FINAL FINDINGS AND DECISION BY THE DESIGN COMMISSION RENDERED ON January 15, 2015

CASE FILE NUMBER: LU 14-208117 DZ AD PC # 14-169399 Jefferson Street Apartments

SITE PLAN

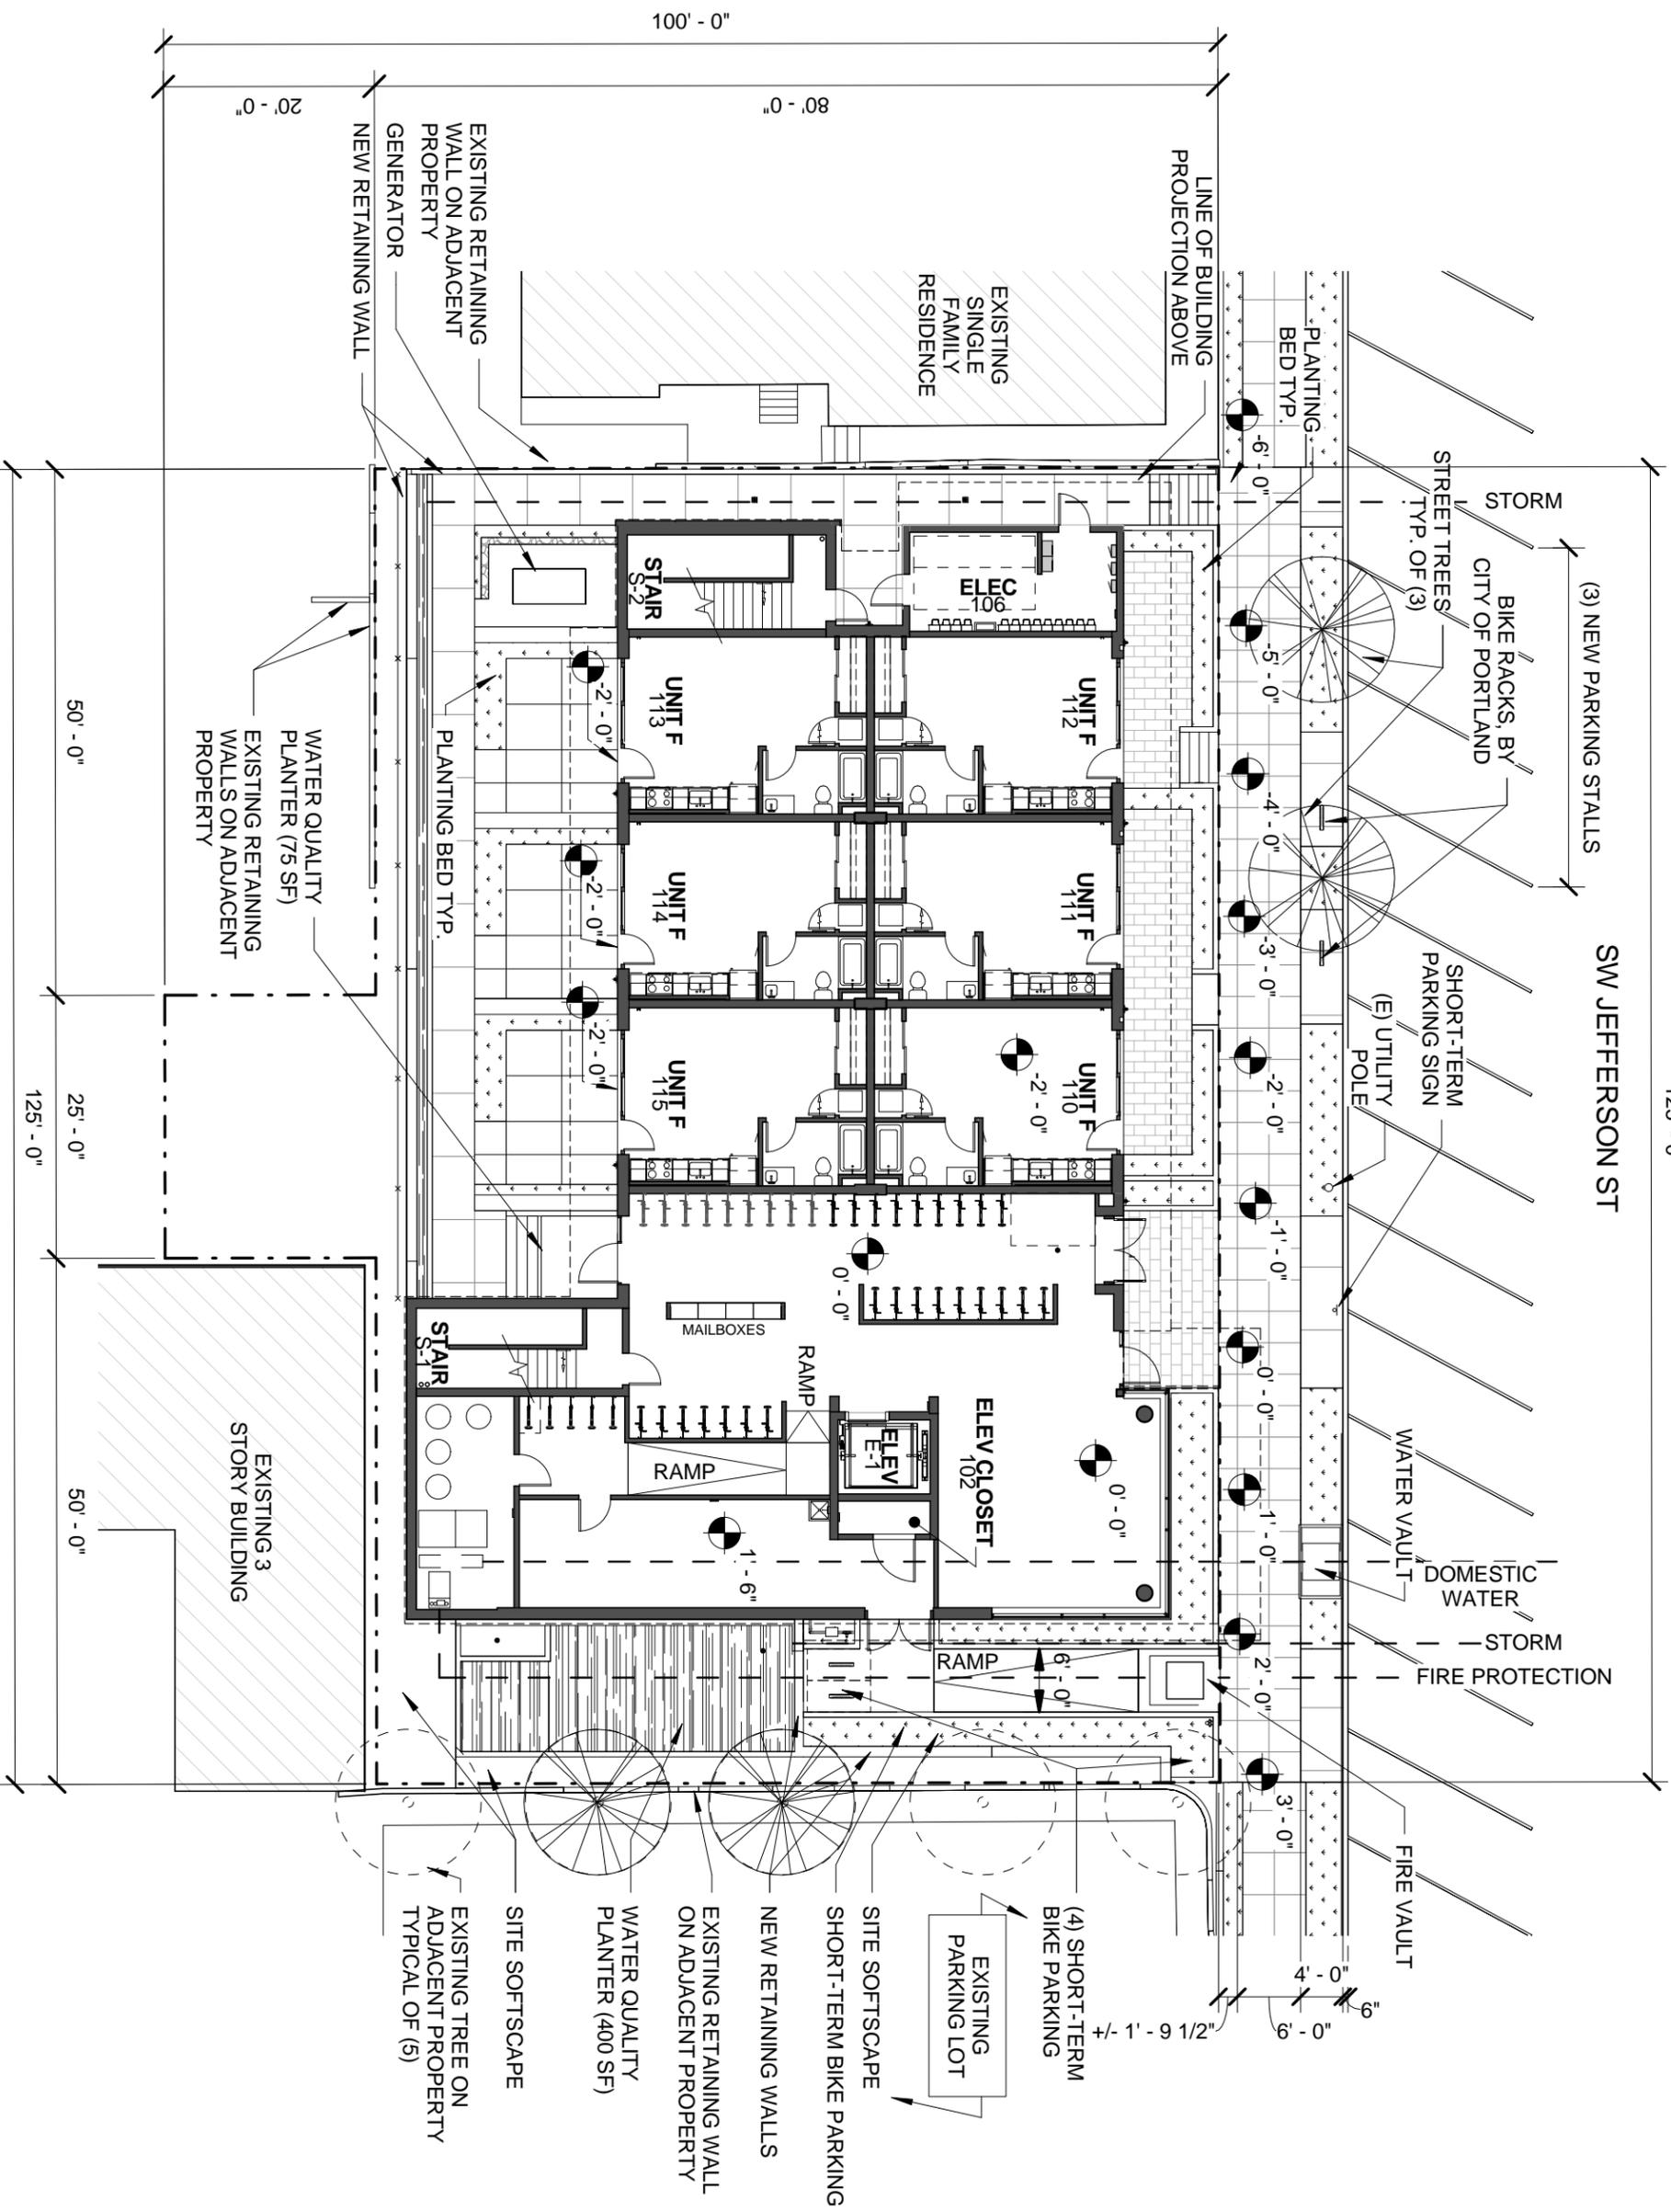
However, the location of the entry to the trash/recycling room between the entries to the main lobby and the ground floor patio units has significant potential to conflict with the use of these spaces as inviting and enjoyable. Moving trash and recycling through the furnishing zone on a weekly basis for curbside pickup would likely result in significant impacts to pedestrian enjoyment related to odor, noise and forecourt surface damage.

With the condition that access to the trash/recycling room be moved to the southeast corner of the site, the pedestrian vitality of the forecourt and sidewalk will be better ensured.

Each Land Use Review Commission concern has been addressed and incorporated into the Jefferson Apartments design and Project Documents. The Recycling Room has been relocated to the east side of the ground floor and is provided with ramped interior access. The sidewalk leading from Recycling Room exit door to the Public Right of Way has been revised from tiered to ramped, ensuring a fully accessible path of travel. The rooftop mechanical unit has been screened with vertical ribbed metal siding. Planter walls along Jefferson street frontage have been reduced in height by one-two feet, with top of wall elevations noted (North Elevation).
